**ORTHODYNE[®]
ELECTRONICS**

PRODUCT UPDATE

030724c

NEW Low Cost Cutter Blade

ALC head with low cost cutter blade installed.

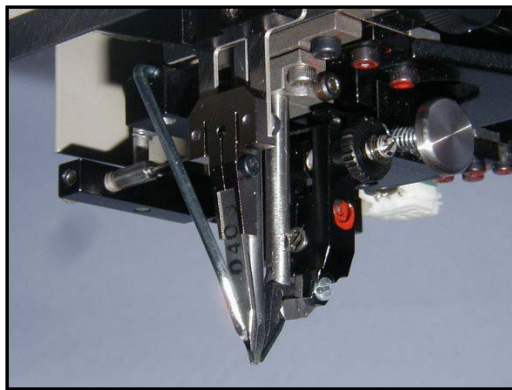
New Two-piece Low Cost Cutter Blade for Front Cut Applications:

Orthodyne Electronics' Commitment to reducing the cost of ownership is highlighted in the re-design of the cutter blade assembly, specifically designed to reduce replacement costs and set-up time for all front cut version deep access systems. This concept, already proven in most ALC head installations, allowed OE to develop a new, lower cost cutter blade. The new design of this two-piece cutter assembly uses a straight replaceable tip mounted into an angled cutter holder. The tips can be quickly replaced with minimal adjustment.

Standard front cut head with low cost cutter blade installed.

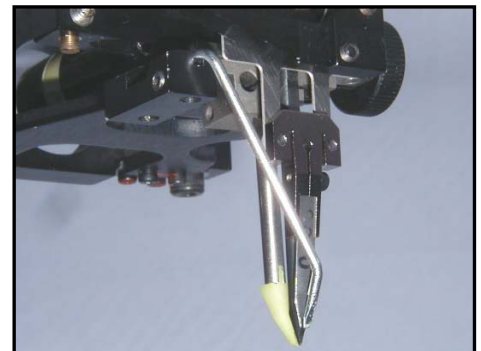
The two-piece cutter assembly can be retrofitted on any Model 360C or ALC (Front Cut only). **Note:** Tail length might have to be adjusted. Also, the same cutter blade is used on Orthodyne's new series wire bonder 3600 and 7200.
